## Library RFP Questions as of 2/09/15

I am writing you to require information concerning the Park City Public Art for The Library Center Entry Hall project.

# Additional Measurements for Library RFP (2/9/2015)

**Park City Library and Carl Winters  
School Building Remodel Project**

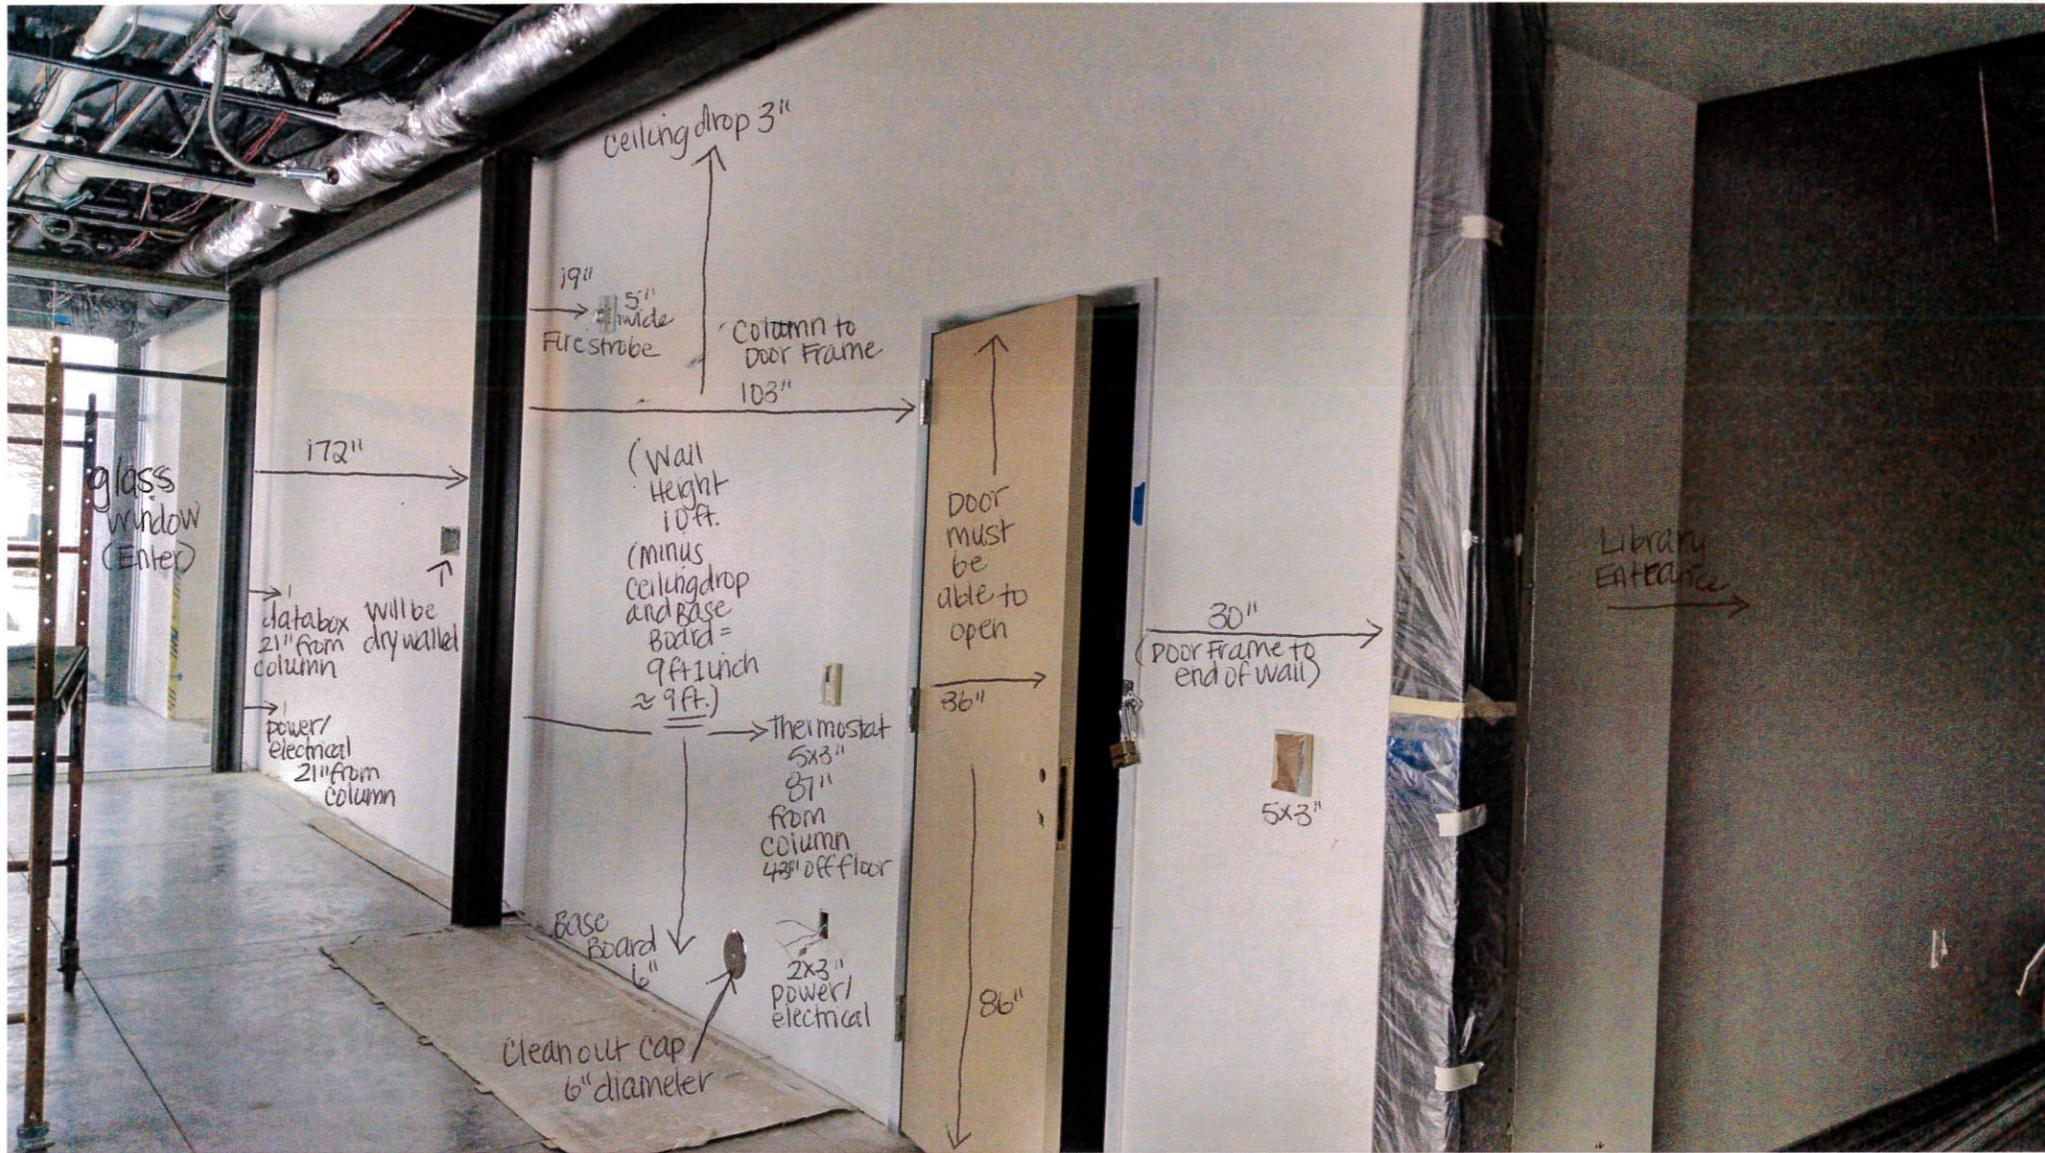
It is not exactly clear to me what the dimensions restrictions are when using the floor for the art piece.

Could you please inform me about this matter?

I am attaching an image with additional measurements that may be helpful to you.

\* Wall Height has been modified to 9ft., due to ceiling drop + baseboard.

Lobby/Entry Gallery Wall **C5**  
11/2"=1'-0"

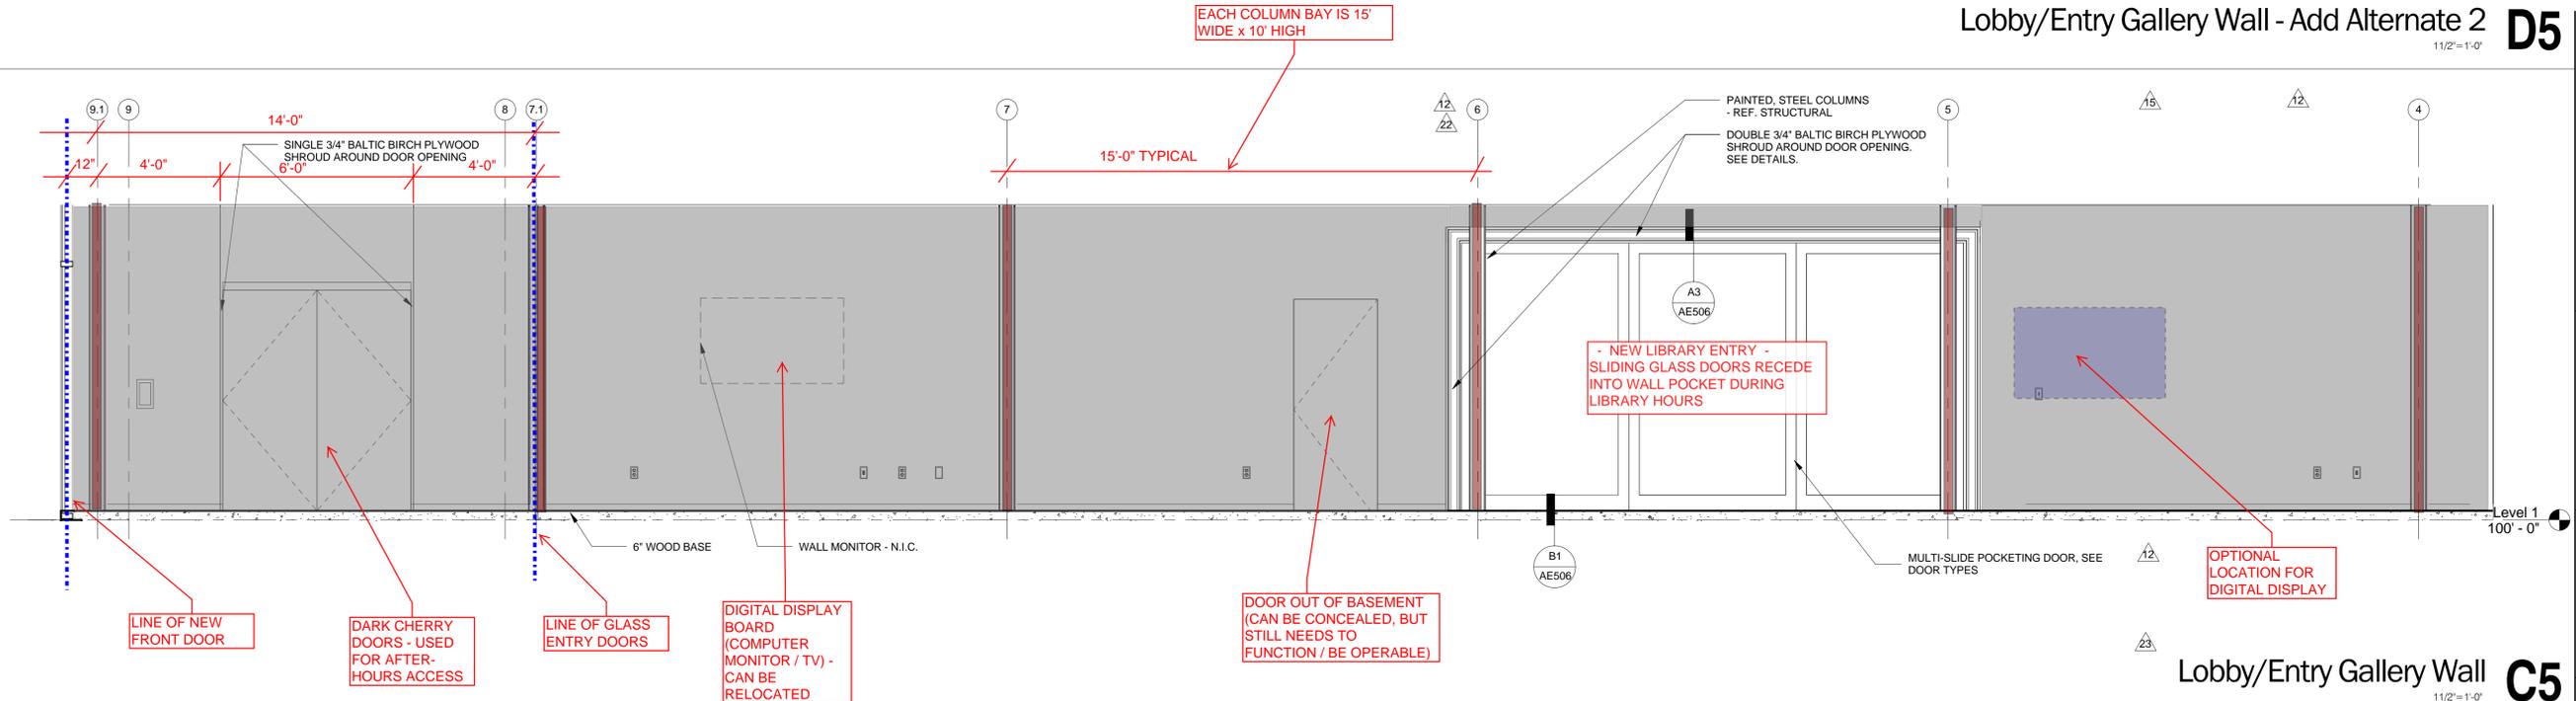
Could you explain a little more the dimensions of the wall and placement of "obstacles"? Could you walk me through how the wall looks upon entering the very first door? This is how I imagine it...you enter the first door, there is a 14' length of wall then another door. Then \_\_\_\_\_ feet before the first metal support column, then \_\_\_\_\_ feet until the next support column and so on. I'm trying to estimate installation costs.

Please see the attached drawings for more detailed measurements of the space. If you have additional questions, please let me know no later than February 20<sup>th</sup>, 2015.
